subject Hamilton Wetlands Post-Construction As-Built Survey Review – Breach and Completion Contract.

This memorandum presents the ESA's post-construction assessment of the Hamilton Wetland Restoration Project following the Breach and Completion Contract.

Hamilton Post-Construction Assessment
FIGURE 30
 Outboard Levee Cross Sections

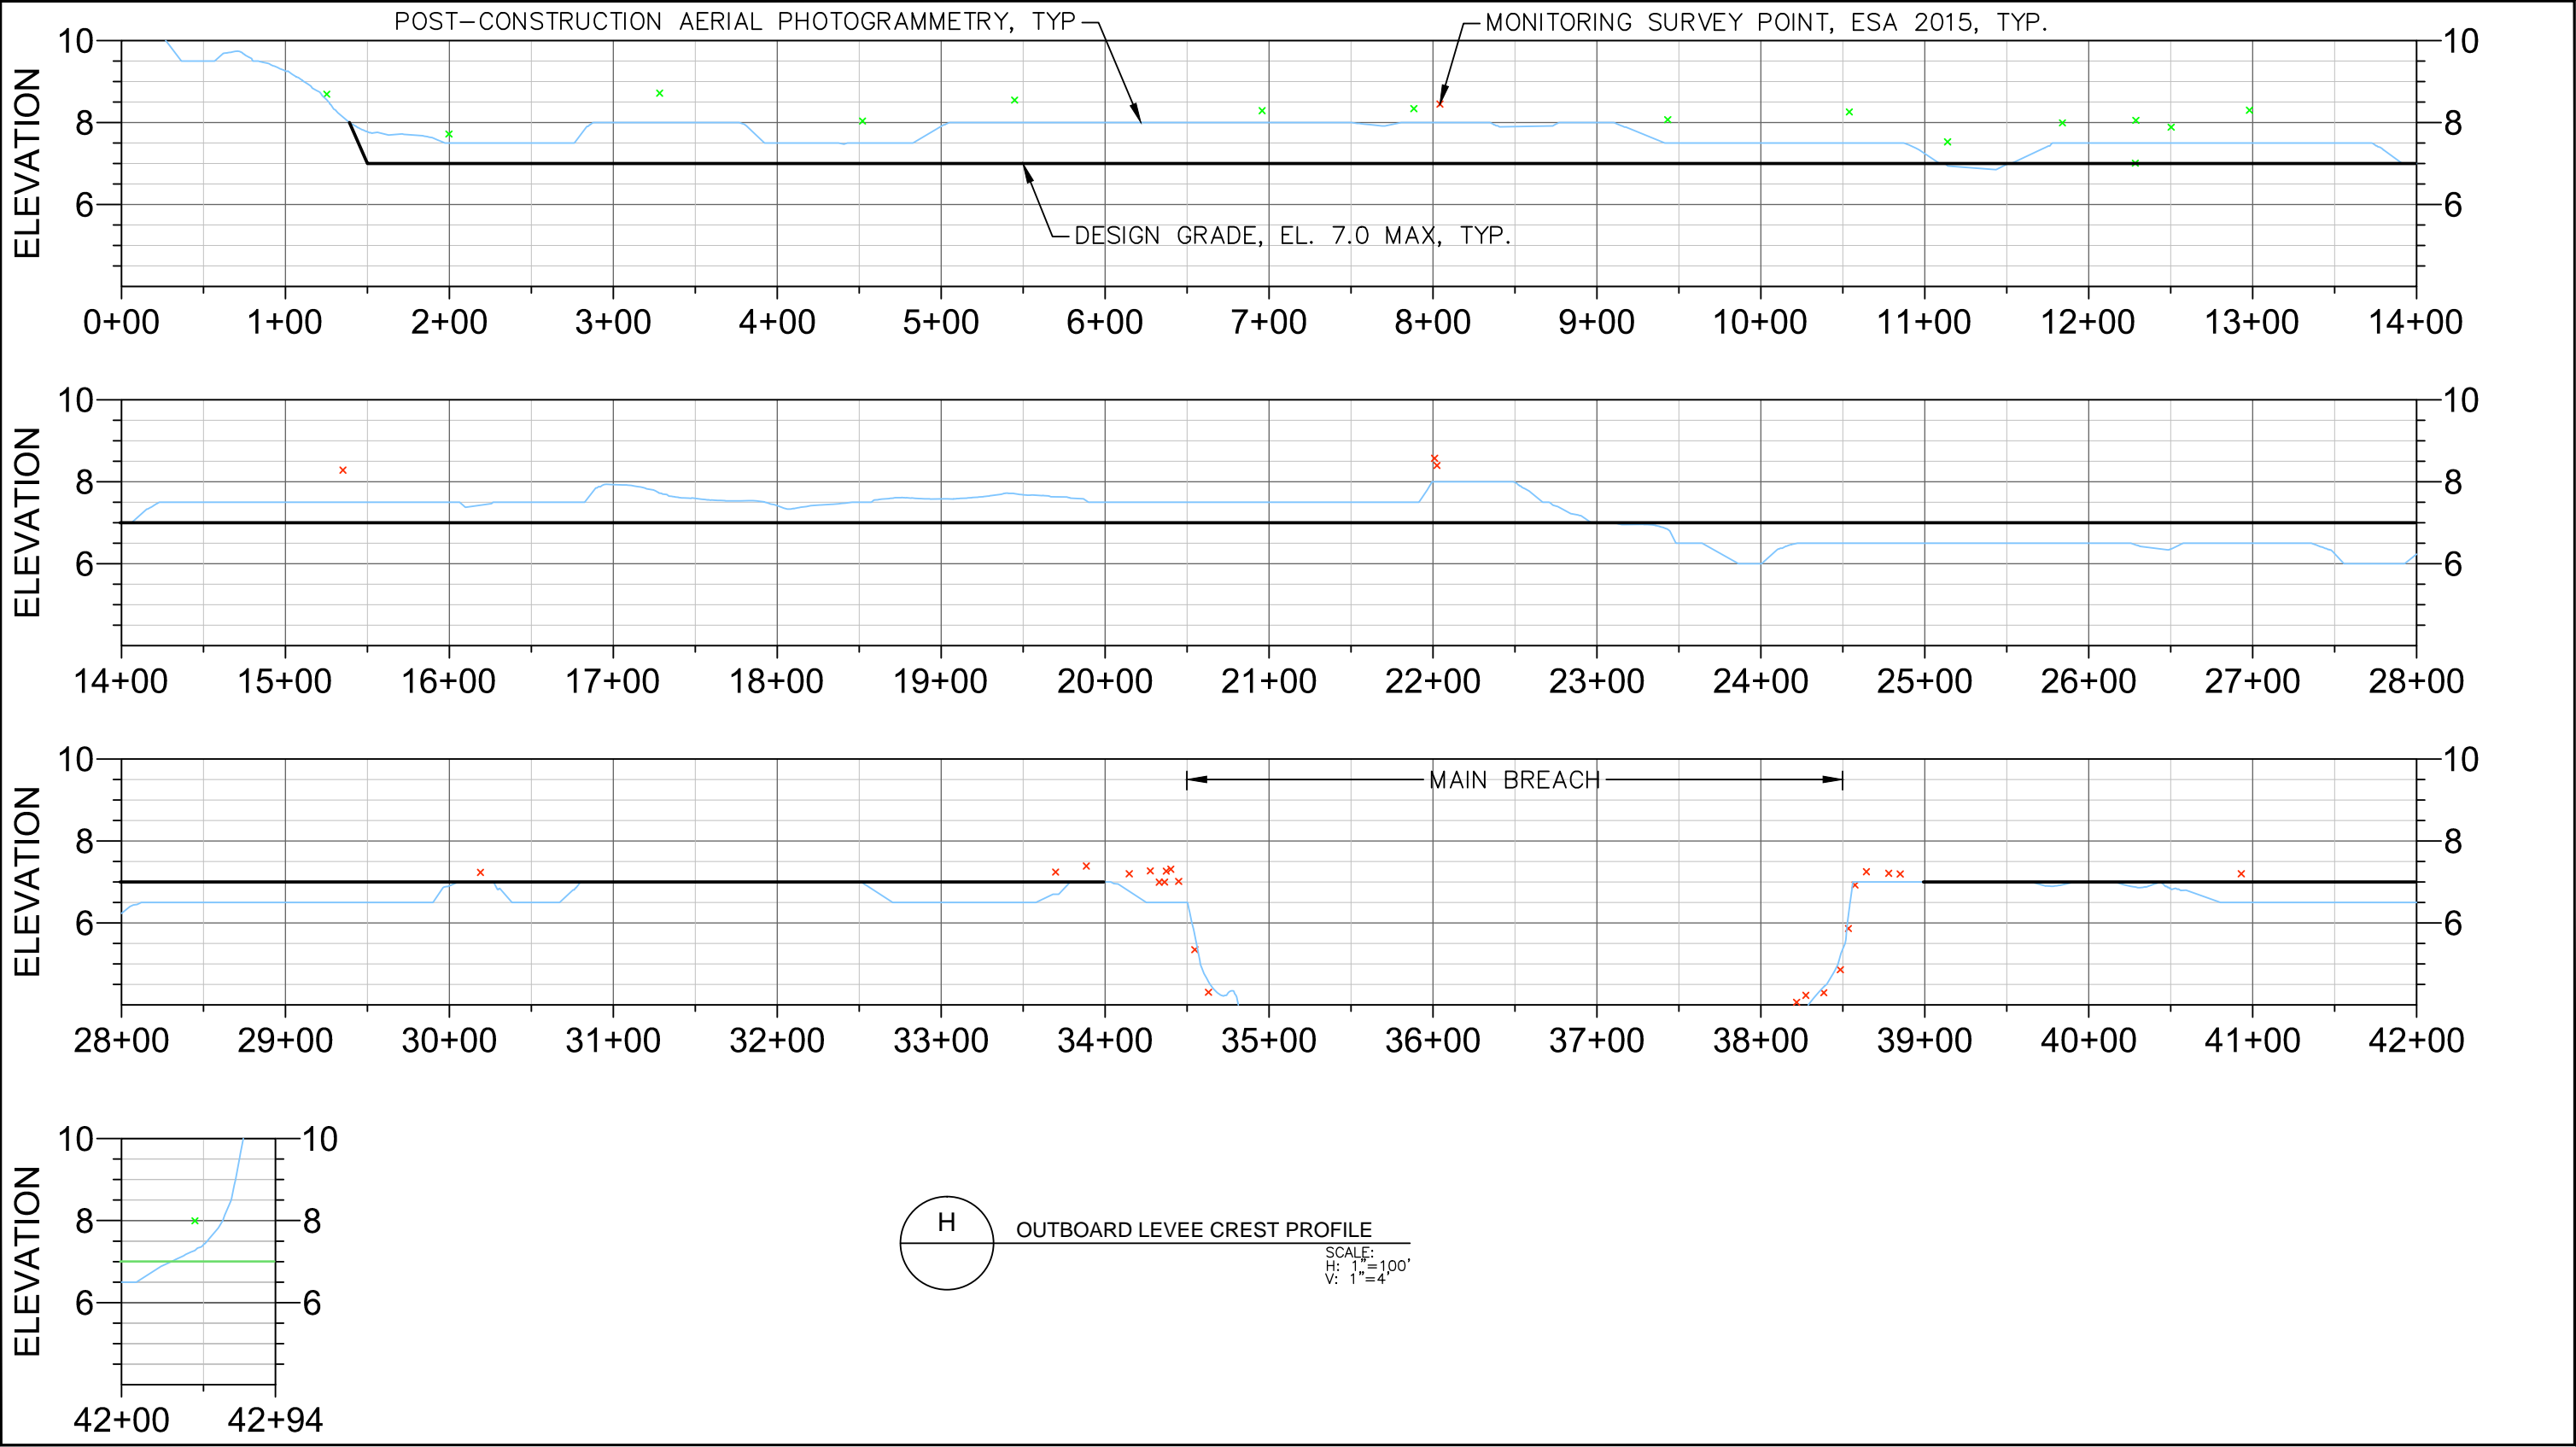
view of the outboard levee, including the location of spot elevations collected by ESA. Figure 30 shows several cross sections cut along the length of the outboard levee, showing as-built grades captured by the aerial photogrammetry as well as the design grade. Figure 31 shows a profile along the centerline of the outboard levee, showing as-built grades captured by the aerial photogrammetry, as well as high points captured in the ESA monitoring survey. This figure also highlights the EL 7.0 ft, the maximum allowed elevation of the lowered levee.

The design indicates that the levee lowering should create a slope from the existing elevation 7.0' contour on the outboard side of the levee to the inboard EL 5.1 ft contour. Therefore we would expect the post-construction grades along the levee centerline to be between EL 5.1 and 7.0 ft, however the post-construction survey shows elevations above EL 7.0 ft almost contiguously between stations 0+00 and 23+00, and at several other locations along the length of the levee. This suggests that nearly half of the outboard levee was not lowered to the correct elevation.

- Lower the outboard levee to design grades including the clean clay soil cap as required by the contract.
 - If lowering the outboard levee is not practicable, native plantings appropriate for high marsh and transitional zones (similar to those for the Wildlife Corridor) should be planted along the higher reaches of the outboard levee limit establishment of non-native vegetation including perennial pepperweed.
